Comment on amt-2022-107 Anonymous Referee #1 comment on "In-situ measurements of NH<sub>3</sub>: instrument performance and applicability" by Marsailidh M. Twigg et al., Atmos. Meas. Tech. Discuss., <https://doi.org/10.5194/amt-2022-107-RC1>, 2022

Response to Anonymous Referee #2 on "In-situ measurements of NH<sub>3</sub>: instrument performance and applicability" by Marsailidh M. Twigg et al., Atmos. Meas. Tech. Discuss., <https://doi.org/10.5194/amt-2022-107-RC2>, 2022

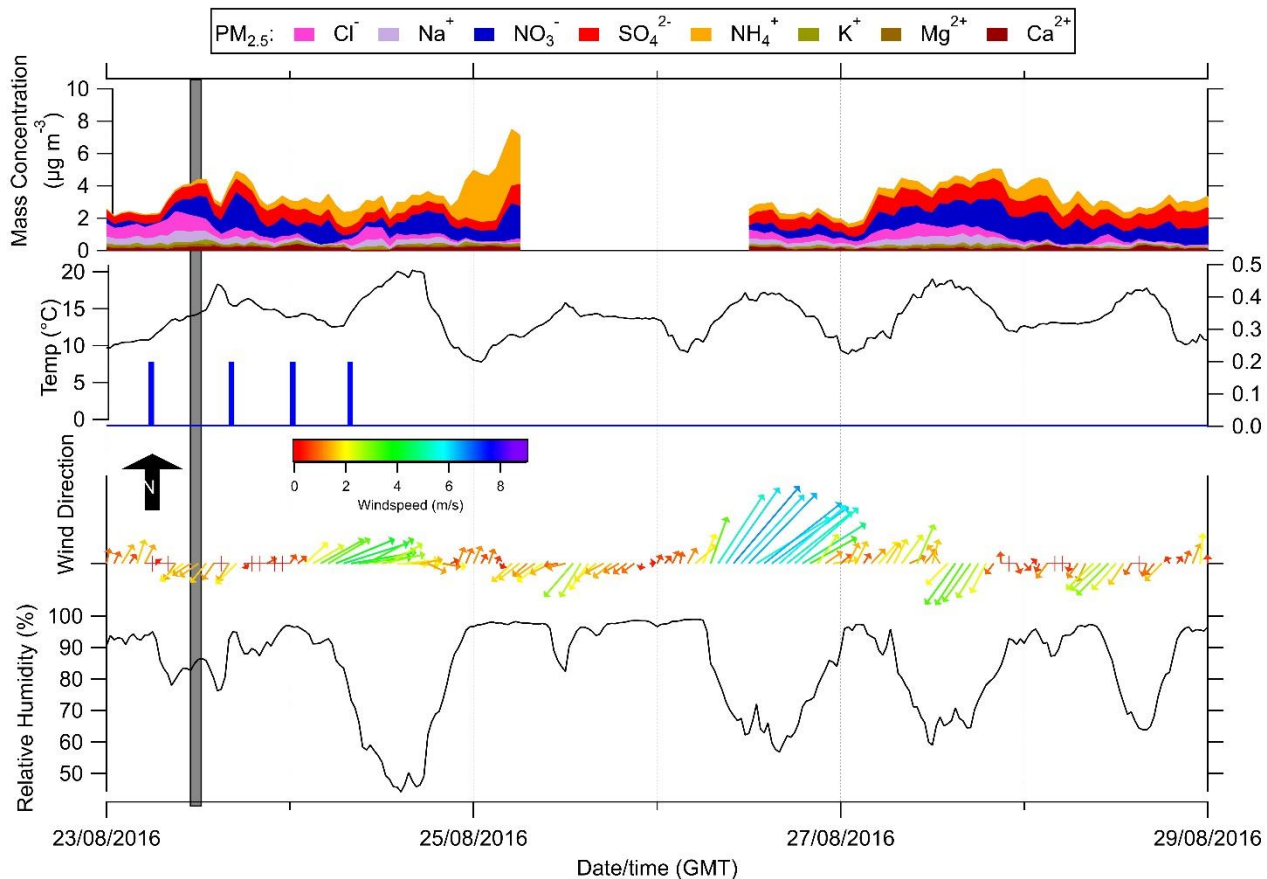
Instruments were in the field from 22 Aug to 2 Sept. Is there a reason that only 23 Aug and 29 Aug is used for the intercomparison study and not the full period? There are inconsistencies in the dates in several places throughout. For example, Figures 8 and 9 and Table 4 suggests a start date of 22 Aug instead of 23 Aug. There are also inconsistencies in the dates in some of the figure captions and table headers in the SI.

Figure 2. Please add something (e.g., shaded bar, horizontal arrow, red dashed lines) to indicate the period of data used for the instrument intercomparison (which I think is 23 Aug to 29 Aug). Is there a reason that the remaining data in the timeseries up to 02 September was not included in the intercomparison?

Though most instruments were in present the field between the 22<sup>nd</sup> August to the 2<sup>nd</sup> September, not all instruments were monitoring ambient air, as other tests were being undertaken. All instruments were operational between the 23<sup>th</sup> August to 29<sup>th</sup> August and therefore this period is the focus of our study. We have removed the periods out with that period. The following text has been reviewed and revised to make clearer the operational periods. In Section 2.4 Data Analysis the following text has been added:

*“Though instruments were deployed for a longer period, for the purpose of this study only the period of the 23<sup>rd</sup> to the 29<sup>th</sup> August is studied unless otherwise stated, as not all instruments were operational at the start and end of the campaign.”*

In addition Section 3.1 was updated to reduce the period of meteorology discussed to cover only the period of the 23<sup>rd</sup> to 29<sup>th</sup> August, as well as reducing the period show in Figure 2 (see below). The text describing period now states:

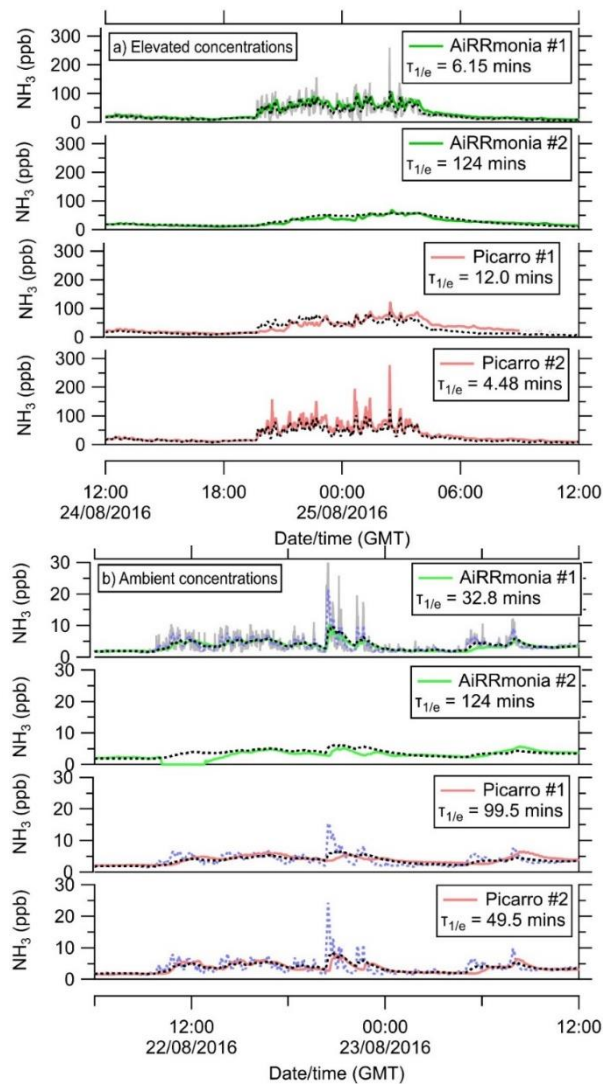
P18, L13: Is the response time truly different under ambient conditions? Without the same level of fine structure in Figure 7b as in Figure 7a, it is difficult to accept the levels of smoothing applied to the DOAS under ambient conditions to match the profiles of the AiRRmonia and Picarro instruments. Can you include another trace in 7b to show the DOAS signal with the same level of smoothing as in 7a? This would help highlight whether additional smoothing of the DOAS is indeed needed to match the features of the AiRRmonia and Picarro instruments under ambient conditions.

We have now updated Figure 7 to include an additional line in Figure 7b which is the smoothing applied in 7a) to demonstrate to the reader the loss in structure and reduced concentrations detected at ambient concentrations.

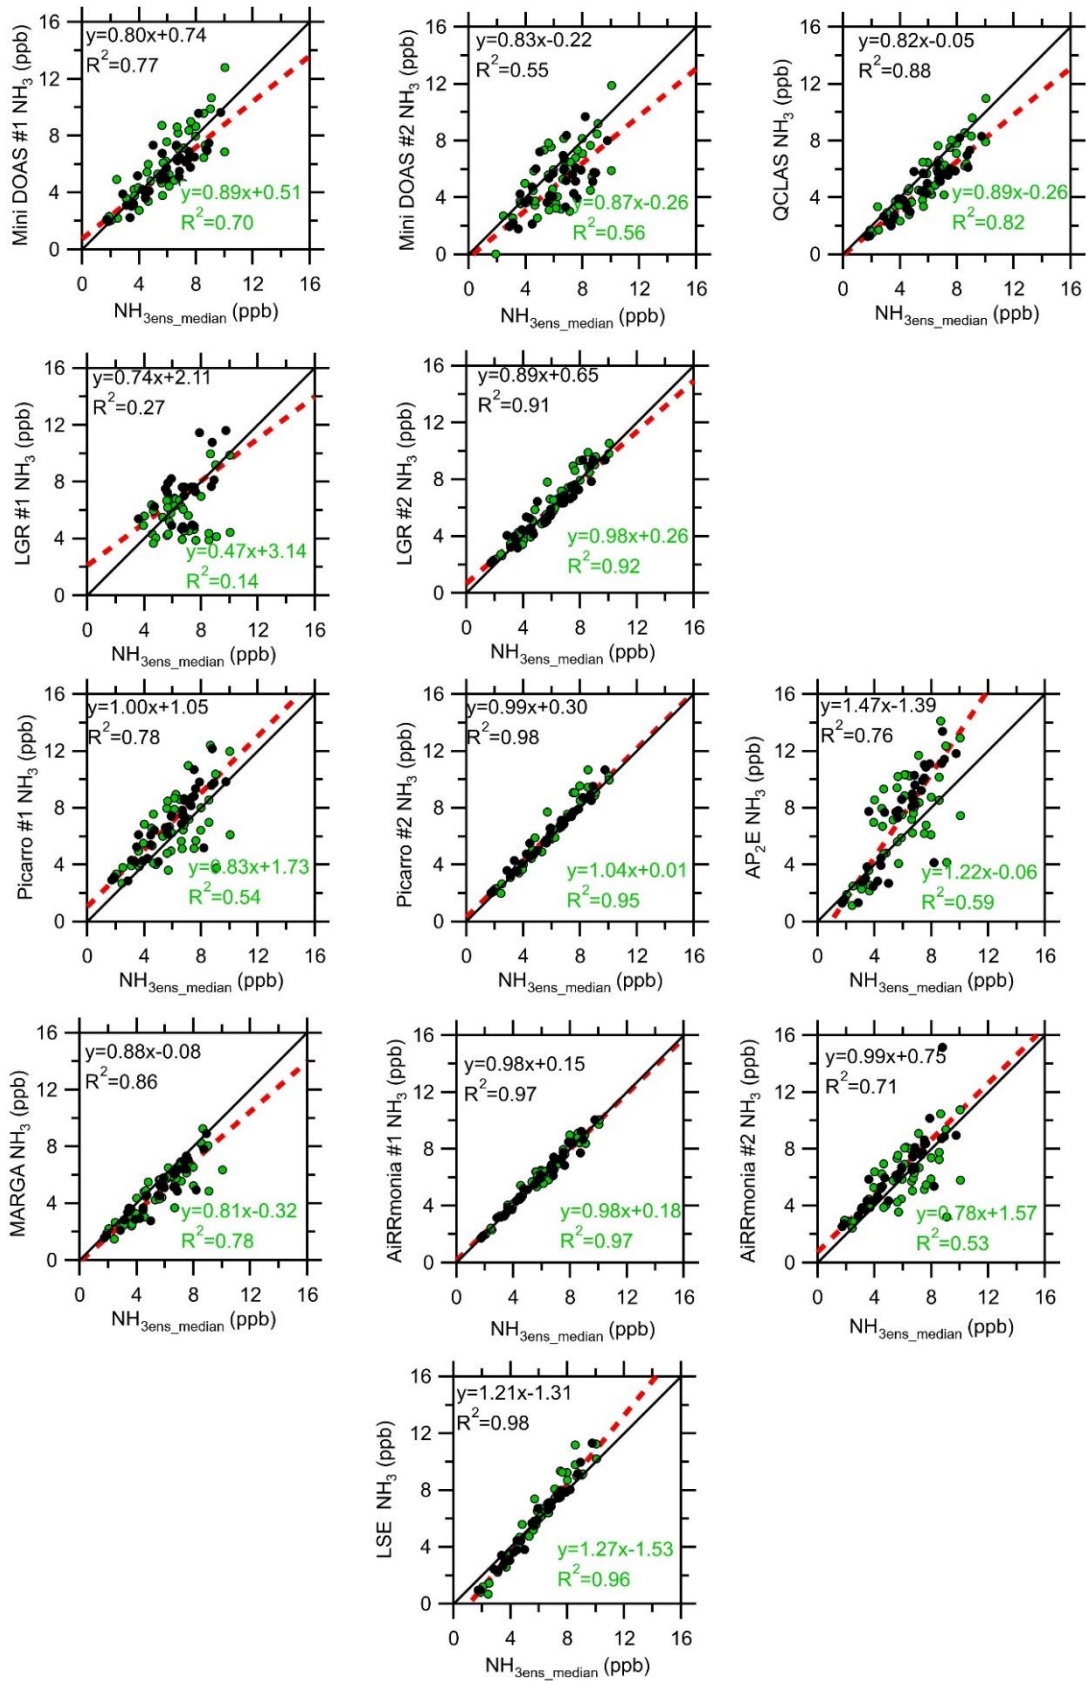
Figure 8. The met filter looks like it could have induced some bias in some of the fits. The met filter was applied to eliminate low wind speed and unstable conditions that could have led to inhomogeneity between the inlets at the field site. But didn't the ALPHA samplers indicate that there was homogeneity during the study period? What do the fits look like without the met filter? At a minimum, you should comment in the text about any differences in fits with and without the met filter applied.

The data presented in Figure 8 includes all data below 10 ppb with the open circles being the data removed after the met filter was applied. The green legend provides information of the comparison for all data, whereas the black legend is the filtered data as outlined in the caption. So the bias is reflected in the difference of the two fits. It is likely that stable conditions that occurred would lead to inhomogeneity of the concentration field and is where the highest concentrations are observed, which the LTMHTR instruments reported. As we have already stated in the text there was an observed improvement in the precision by applying a met filter ( $R^2$ ) however we acknowledge the slope and intercept did alter through the application of the filter on some instruments. For example, for the LGR #2 the slope reduced and the intercept increased due met filter being applied. We have now revised the text to include the following in the manuscript:

*"It is noted, that the slopes and intercepts changed in applying a meteorological filter. In general instruments with faster response found their slopes reduced, whereas the reverse was observed for the instruments with the slower time response. With the exception of the AP<sub>2</sub>E, slopes after filtering were closer to unity and with the additional exception of Picarro #2 the intercepts decreased. For the remainder of this discussion however we will only discuss the filtered data."*

In addition we have modified Figure 8 by colouring the open circles green, in order that it easier for the reader to relate to the green legend:
